service bulletin

M83-3

SUBJECT: ROTO MASTER (Rajay) SERVICE LETTER 27 REVISION A DATED
SEPTEMBER 24, 1982 AND ADDENDUM THERETO DATED FEBRUARY 9,
1983 IN RESPONSE TO FAA AD 82-07-03.

SERVICE LETTER NUMBER 27

FIG. 1

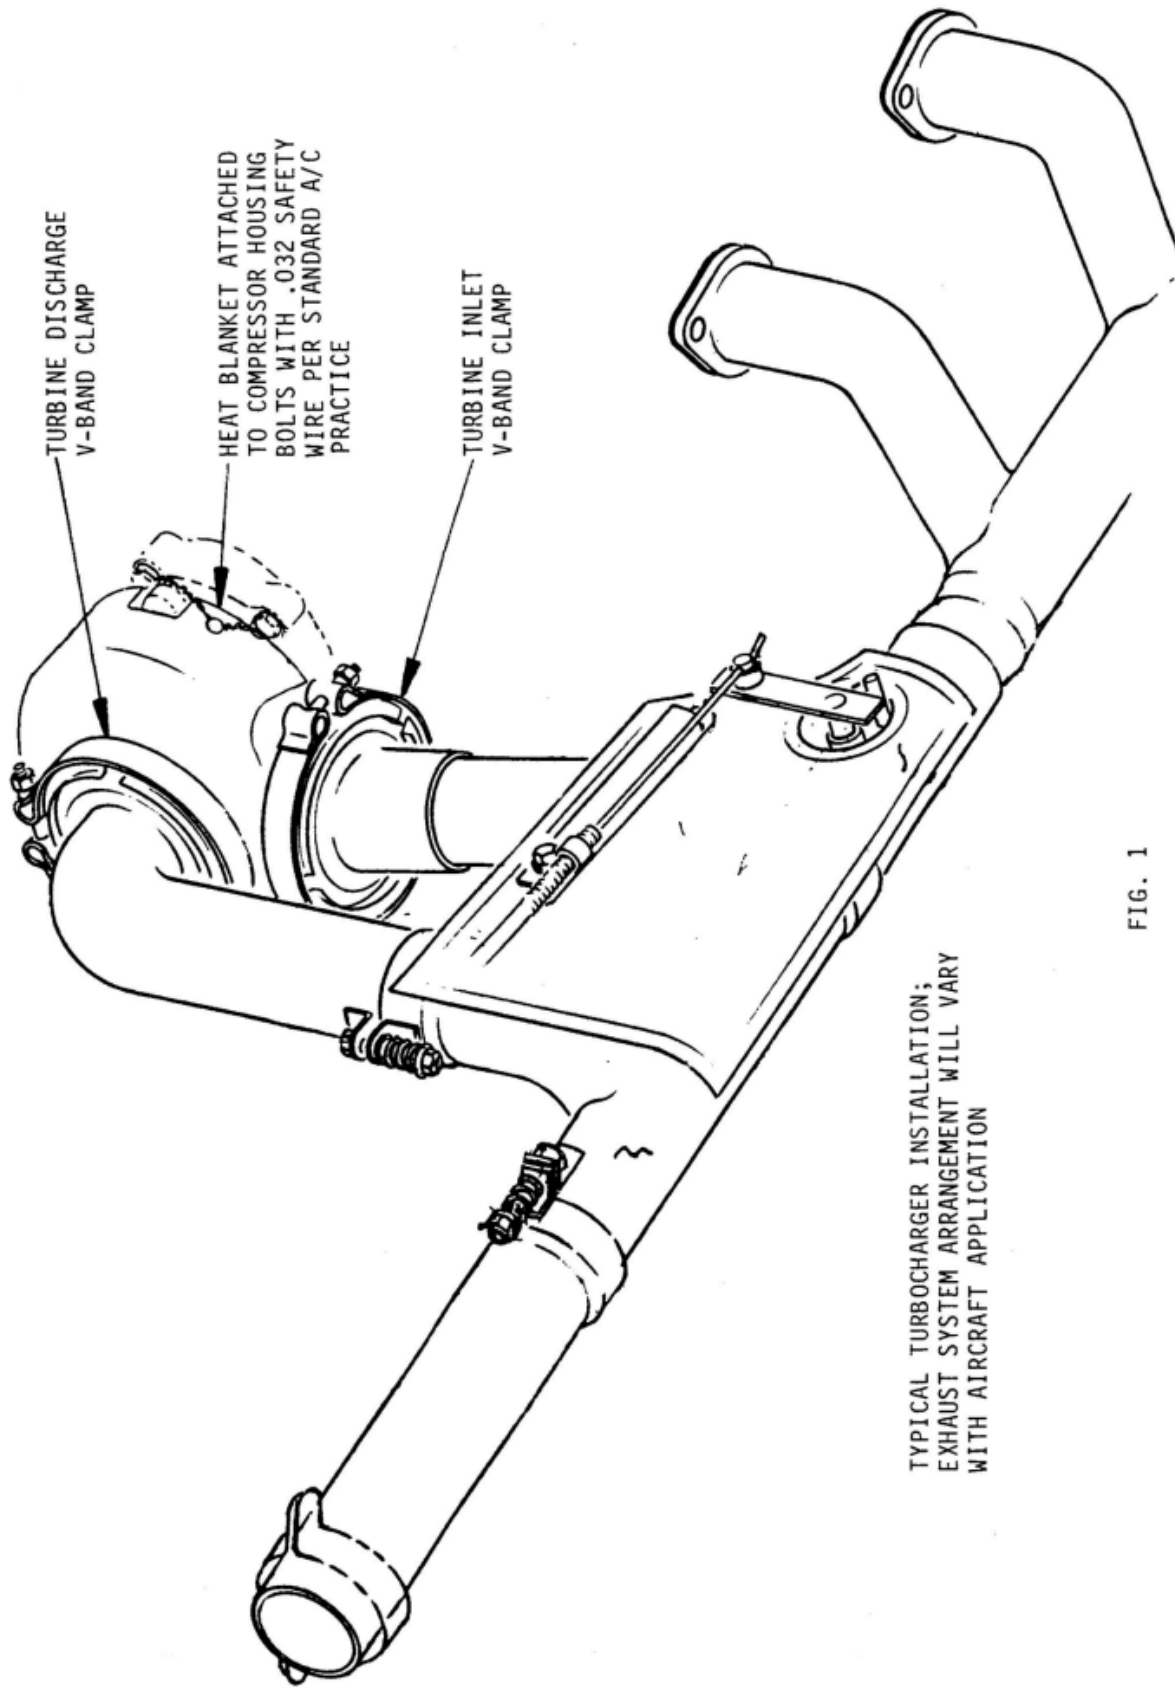
In certain aircraft installations, it may be possible to inspect the turbine housing inner and outer walls for penetrating cracks per Views 1 and 3, without removal of the turbocharger from the aircraft. In any event, the exhaust manifold must be disconnected from the coupling V-band so that the turbine housing internal area near the nozzle can be seen as shown in View 2. If a thermal blanket is installed on the turbine housing, it must be removed. (See Figure 1.)

1. Remove the turbine housing blanket (if installed). (See Figure 1.)
2. Disconnect the exhaust manifold by removing the coupling V-bands.
3. Make "index marks" on the turbine housing and on the aluminum bearing housing so the turbine housing will be reinstalled in the same correct rotational position.
4. Remove the V-band nut and carefully remove the bearing housing V-band (P/N 600391).
5. Remove the turbine housing from the bearing housing and inspect per Description A.1. and 2. Light tapping at the joint with a rawhide mallet will help separate them.
6. While the housing is off, inspect the turbine wheel and heat shield for condition and/or foreign object damage.

VIEW 1 Turbine Housing Exhaust Inlet Internal Cracks.

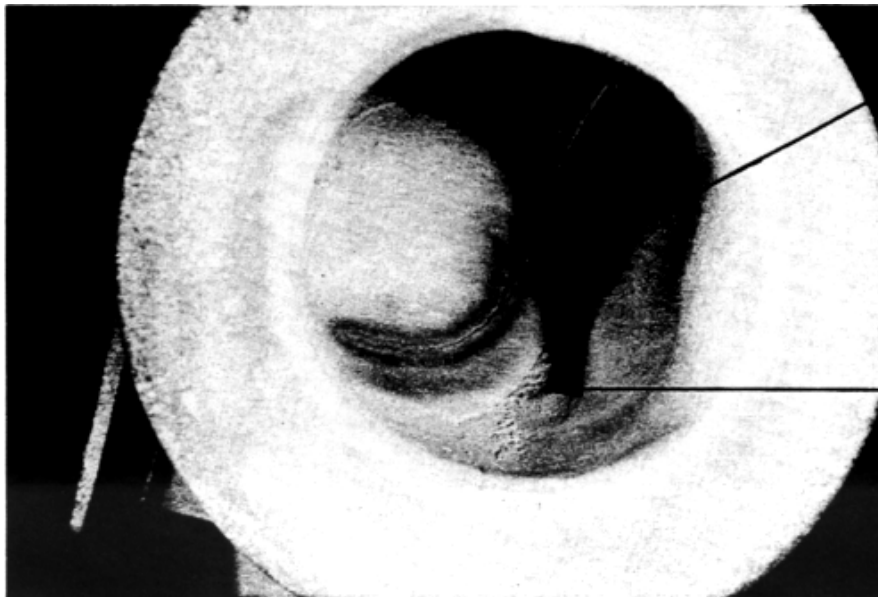
1. Inspection of Turbocharger Installed on Engine - After the initial 50 hours Turbocharger time-in-service operation and/or at next aircraft annual and/or 100 hours inspection, whichever occurs first, and thereafter at every 200 hours unit time-in-service, but not later than May 31, 1983. Visually inspect the Turbocharger turbine housing to ascertain possible presence of cracks penetrating the outer wall as shown in View 3.
 - a. If Outer Wall Is Penetrated - Replace the turbine housing and gasket with a new P/N 600510-04 (TCM P/N 643931**) housing and new P/N 600400-00 (TC-6-30) (TCM P/N 643932**) gasket prior to the next flight.
2. Inspection of Turbocharger Removed from Engine - Visually inspect the turbocharger turbine housing through the exhaust port for presence of cracks as shown in View 1.

INTERNAL CRACK

Cracks in this area are allowable to a length of .75 inch maximum.

Do not misrepresent the casting parting line in this area as a crack.

VIEW 2 View of Turbine Housing with turbo center section removed.

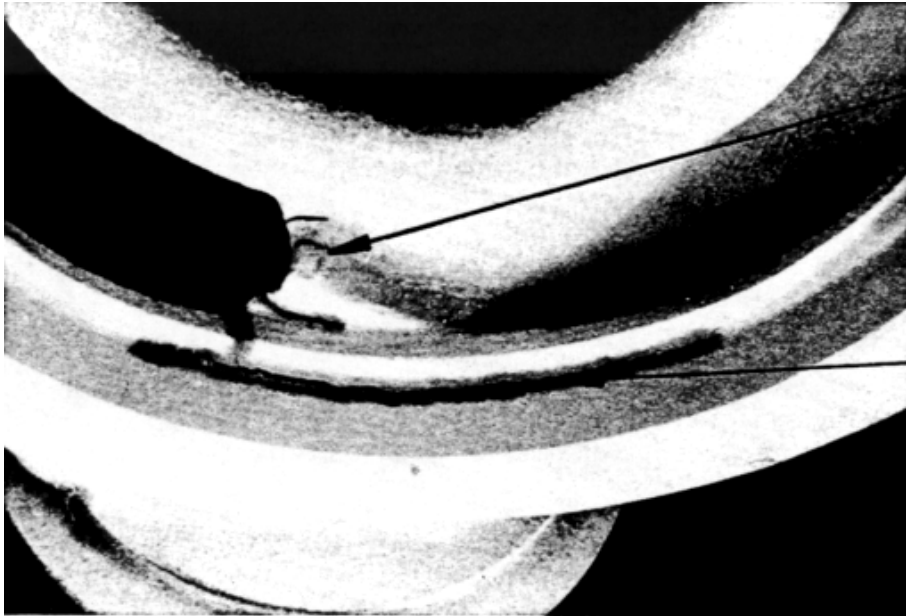
In any case, when a crack penetrates the outer wall of a turbine housing as shown in View 3, the turbine housing and gasket must be replaced prior to the next flight.

Cracks in this area allowable to 3/4 inch.

Cracks in this area allowable to 2 inches.

VIEW 3 View of Turbine Housing with external cracks

No cracks of any length in this area. If cracked, replace immediately.
